Access Compliance Report Public Rights-of-Way (Curb Ramps)

Main Street: ROSSMOOR_CENTER_WAY Cross Street: N/A Location: NE

ADA ID: RPRK211208120554 Ramp Type: Type 5 - Combination 2 Initial Pass/Fail: Fail Overall Compliance: No Severity Score: 16

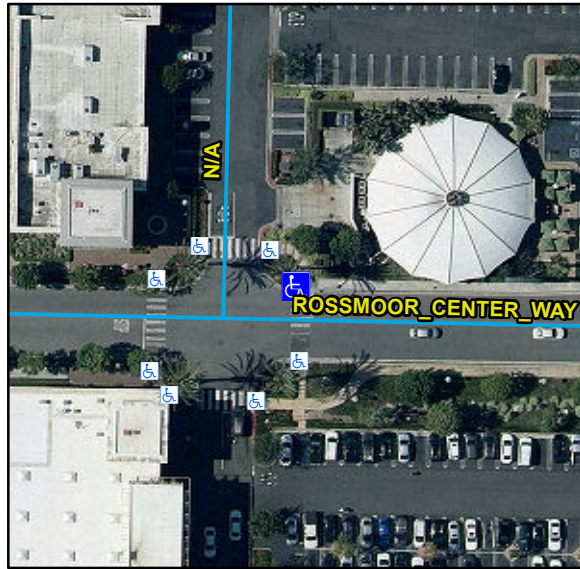
R304.2.2, R304.5.3, STD 1115

Compliance	Description	Data	Compliance	Description	Data
N/A	Ramp Length LT (in)	N/A	N/A	Ramp Length RT (in)	71
N/A	Ramp Width LT (in)	N/A	Yes	Ramp Width RT (in)	54
N/A	Ramp Run Slope LT (%)	N/A	Yes	Ramp Run Slope RT (%)	5
N/A	Ramp Cross Slope LT (%)	N/A	No	Ramp Cross Slope RT (%)	3.3
N/A	Ramp Length (in)	146	N/A	Flare Type LT	
Yes	Ramp Width (in)	72			N/A
No	Ramp Run Slope (%)	9	N/A	Flare Slope LT (%)	N/A
No	Ramp Cross Slope (%)	3.3	N/A	Flare Traversable LT	N/A
N/A	Landing Present	N/A	N/A	Flare Type RT	
N/A	Landing Length (in)	N/A			N/A
N/A	Landing Width (in)	N/A	N/A	Flare Slope RT (%)	N/A
N/A	Landing Run Slope (%)	N/A	N/A	Flare Traversable RT	N/A
N/A	Landing Cross Slope (%)	N/A	N/A	DWS Provided	N/A
N/A	Landing Movement Obstructed?	N/A	N/A	DWS Contrast	N/A
	Landing Movement Type	N/A	N/A	DWS Length (in)	N/A
N/A	Landing Shared	N/A	N/A	DWS Full Width	N/A
N/A	Clear Space	N/A		DWS Offset Type	N/A
N/A	Clear Space To Crosswalk (in)	N/A	N/A	DWS Offset Left (in)	N/A

Remove & Replace Entire Ramp.
